Waste Isolation Pilot Plant

FEPs Screening Analysis

NS-1: Dewey Lake Data Collection and Compilation

**Summary Memo of Record for NS-1:
PA Conceptualization of Dewey Lake**
Lead Staff Member: M. Wallace, RE/SPEC Inc. (6115)

Fig. NS-A1.4 Interpreted General Water Table Surface
(meters above mean sea level)

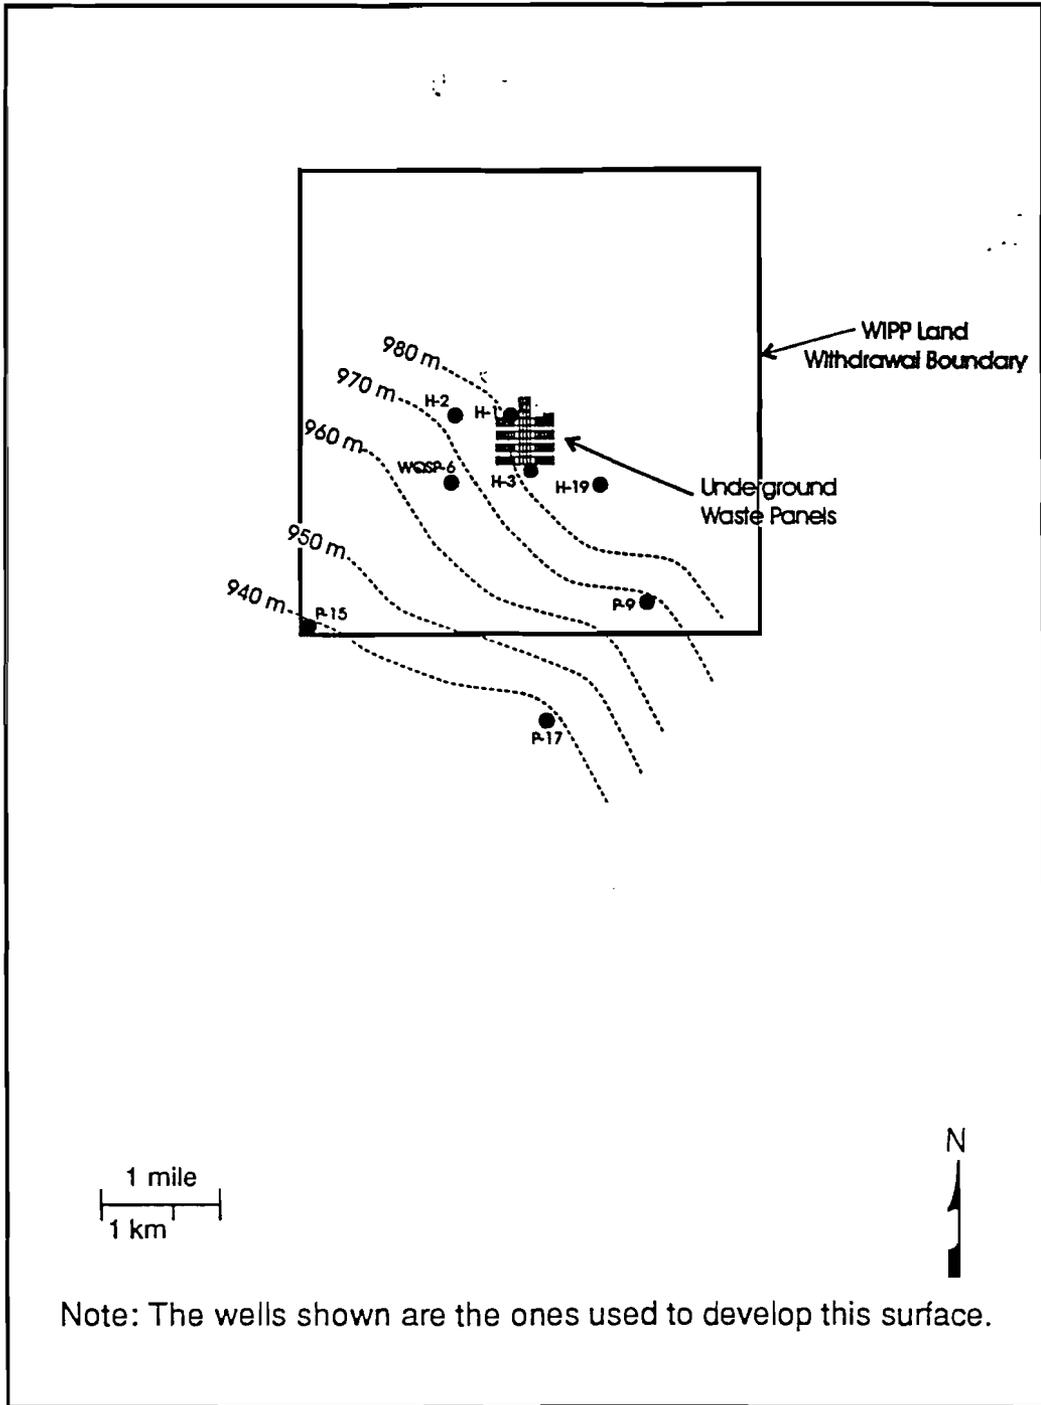
A hand-written note from
Rick Beauheim to Mike Wallace
~ August 1995

I used this information to help develop the
water table map in the SMOR (fig. NS-A1.4)
